May 2020  
FL847AB  
NHTSA #20V-211  
Transport Canada #2020-155

## Subject: Tire Rating Labels

**Models Affected: Specific Model Years 2020-2021 Freightliner 108SD, 114SD, and Coronado vehicles; Western Star 4700 and 4900 vehicles manufactured April 26, 2019 through March 9, 2020.**

**Fig. 4, Component GWR Label Location, Coronado**

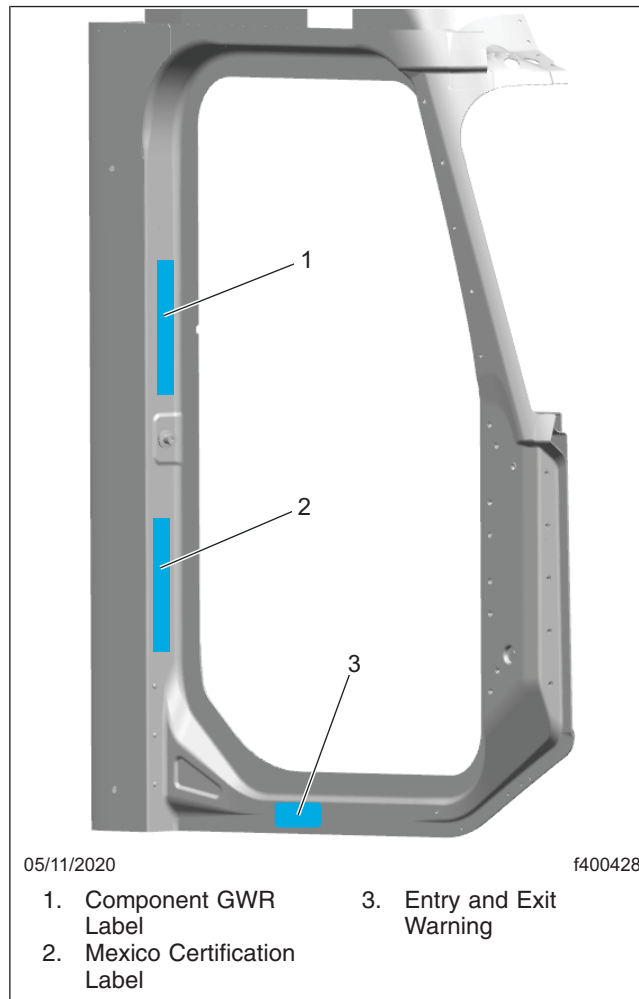
On certain vehicles, the Gross Axle Weight Rating (GAWR) on the certification label lists an incorrect higher capacity of the tires, which can lead to possible overloading of the tires and increase the likelihood of a crash.

- Open the passenger side door, and locate the component GWR label. See [Fig. 4](#). See [Fig. 5](#) for an example of a Freightliner component GWR label.

5. Remove the current component GWR label by peeling the clear topcoat label off, and then remove the white base label.

6. Clean the adhesive residue from the label location.
7. Ensure that the area on the door is clean and dry, and then affix the new component GWR label with the correct GAWR on it.
8. Clean a spot on the base label (Form WAR259), write recall number FL847 on a blank red completion sticker (Form WAR260), and attach it to the base label.

Fig. 6, Component GWR Label Location, Recall Kit, Freightliner

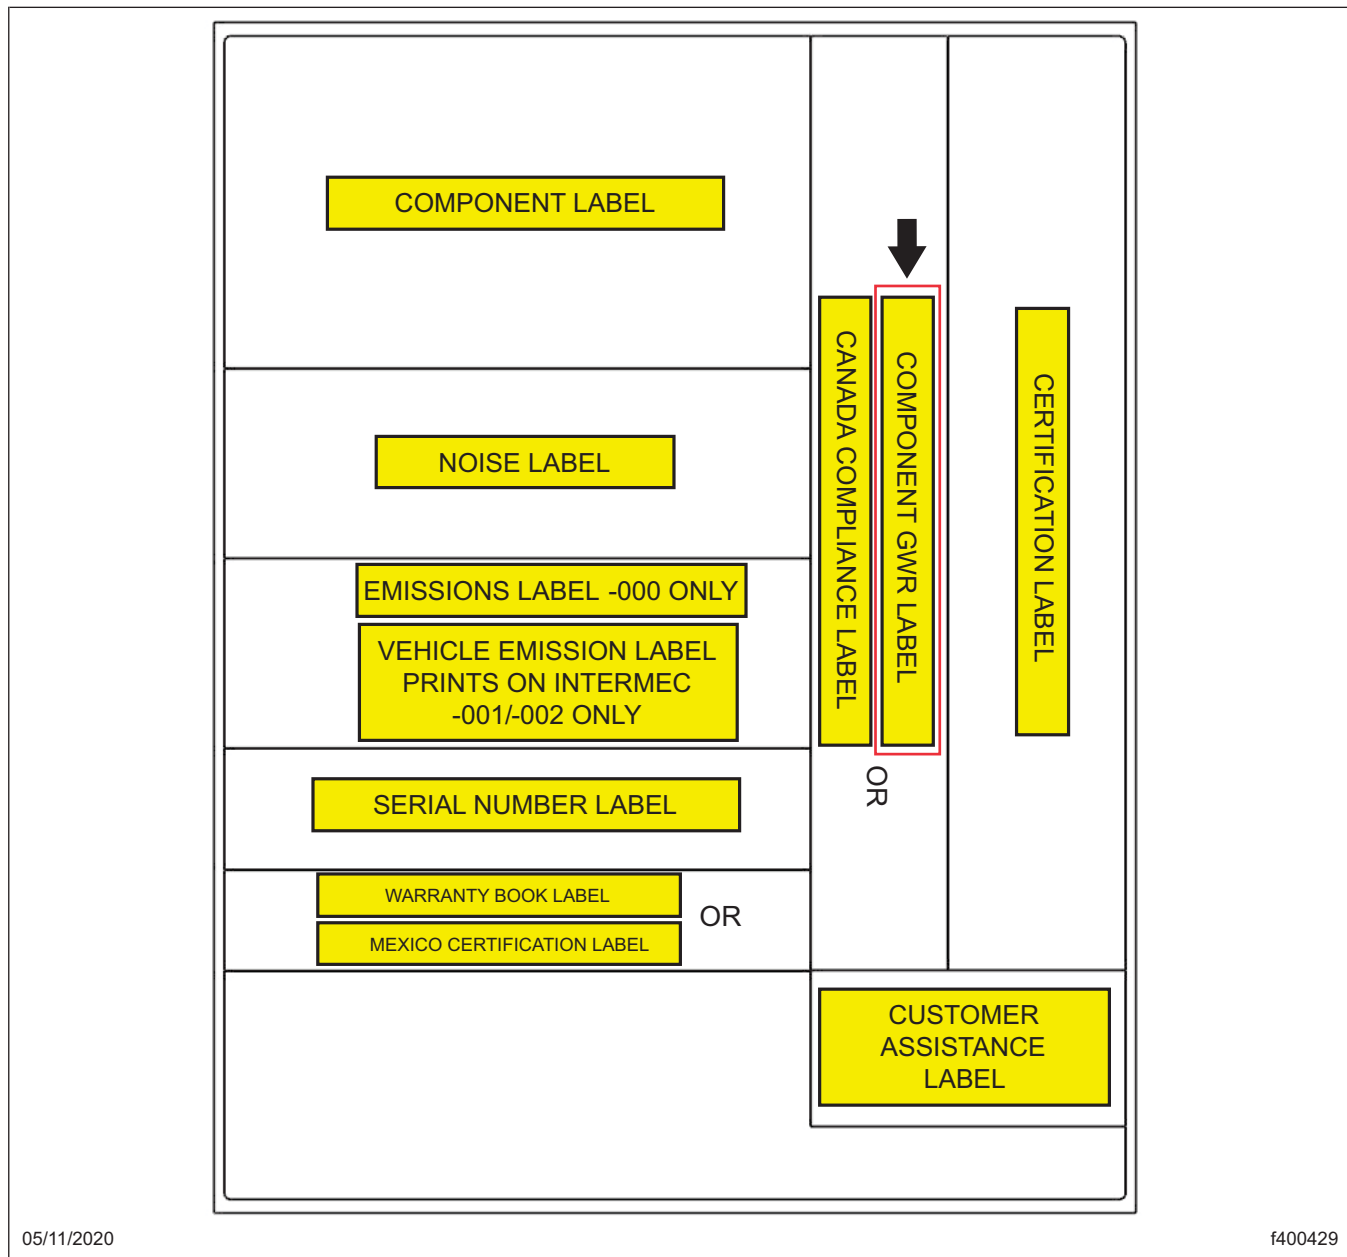
4. Locate the new component GWR label. See Fig. 6. Make sure the VIN on the current component GWR label matches the VIN on the new component GWR label.

**Fig. 7, Component GWR Label Location, 108SD and 114SD**

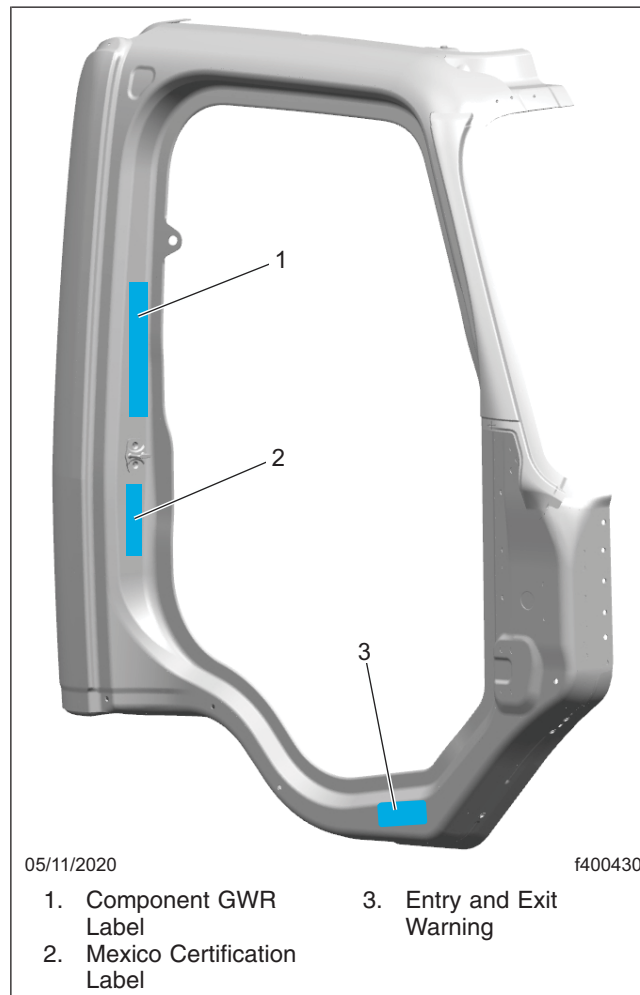
1. Check the base label (Form WAR259) for a completion sticker for FL847 (Form WAR260) indicating this work has been done. The base label is usually located on the passenger-side door about 12 inches (30 cm) below the door latch. If a completion sticker is present, no work is needed. If a completion sticker is not present, continue with the next step.
2. Park the vehicle on a level surface, apply the parking brakes, and shut down the engine. Chock the tires.
3. Open the passenger side door, and locate the component GWR label. See [Fig. 7](#). See [Fig. 5](#) for an example of a Freightliner component GWR label.

5. Remove the current component GWR label by peeling the clear topcoat label off, and then remove the white base label.
6. Clean the adhesive residue from the label location.
7. Ensure that the area on the door is clean and dry, and then affix the new component GWR label with the correct GAWR on it.
8. Clean a spot on the base label (Form WAR259), write recall number FL847 on a blank red completion sticker (Form WAR260), and attach it to the base label.

**Fig. 8, Component GWR Label Location, Western Star Trucks, U.S.**

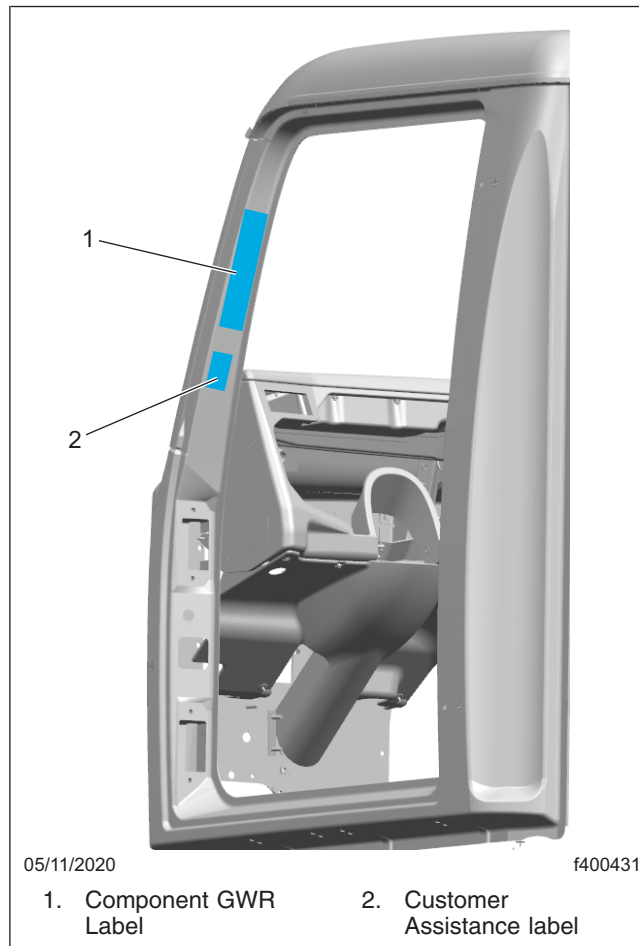
3. Open the driver side door, and locate the component GWR label. See **Fig. 8**. See **Fig. 5** for an example of a Freightliner component GWR label.

5. Remove the current component GWR label by peeling the clear topcoat label off, and then remove the white base label.

6. Clean the adhesive residue from the label location.
7. Ensure that the area on the door is clean and dry, and then affix the new component GWR label with the correct GAWR on it.
8. Clean a spot on the base label (Form WAR259), write recall number FL847 on a blank red completion sticker (Form WAR260), and attach it to the base label.

**Fig. 9, Component GWR Label Location, Recall Kit, Western Star**

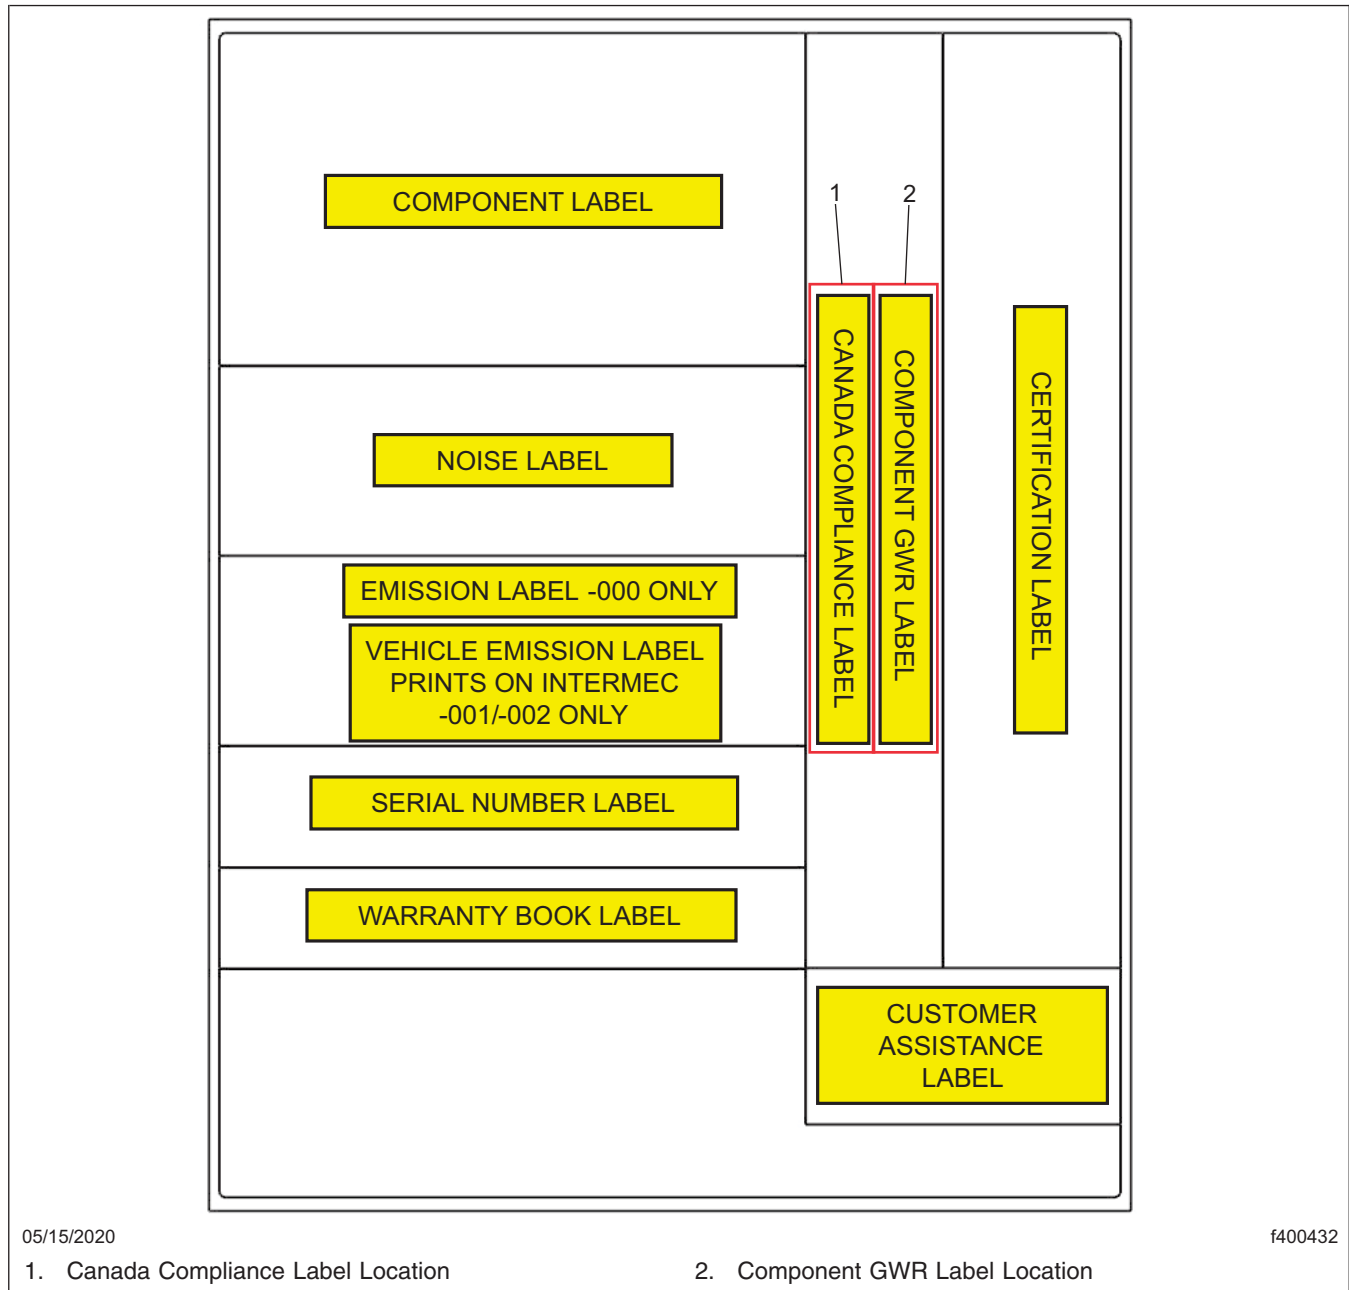
4. Locate the new component GWR label. See **Fig. 9**. Make sure the VIN on the current component GWR label matches the VIN on the new component GWR label.

4. Locate the new component GWR label and the new Canada Compliance label. See [Fig. 9](#). Make sure the VIN on the current component GWR label matches the VIN on the new component GWR label.

**Fig. 10, Canada Compliance Label Location, Western Star Trucks, U.S.**

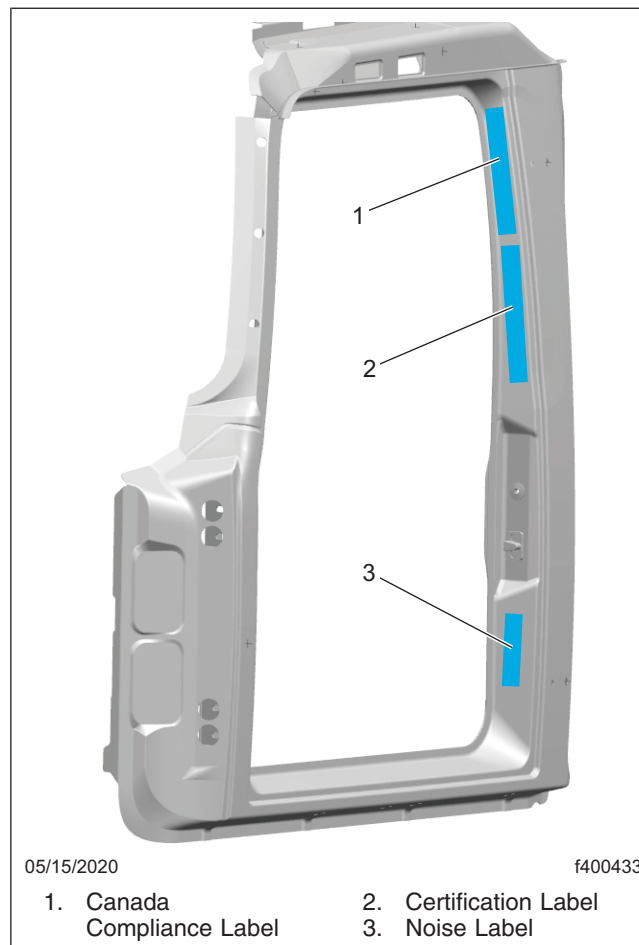
1. Check the base label (Form WAR259) for a completion sticker for FL847 (Form WAR260) indicating this work has been done. The base label is usually located on the passenger-side door about 12 inches (30 cm) below the door latch. If a completion sticker is present, no work is needed. If a completion sticker is not present, continue with the next step.
2. Park the vehicle on a level surface, apply the parking brakes, and shut down the engine. Chock the tires.
3. Open the driver side door, and locate the component GWR label and the Canada Compliance label. See [Fig. 8](#) and [Fig. 10](#). See [Fig. 5](#) for an example of a Freightliner component GWR label.

5. Remove the current component GWR label and the Canada Compliance label by peeling the clear topcoat label off, and then remove the white base label.
6. Clean the adhesive residue from the label location.
7. Ensure that the area on the door is clean and dry, and then affix the new component GWR label and the Canada Compliance label with the correct GAWR on it.
8. Clean a spot on the base label (Form WAR259), write recall number FL847 on a blank red completion sticker (Form WAR260), and attach it to the base label.
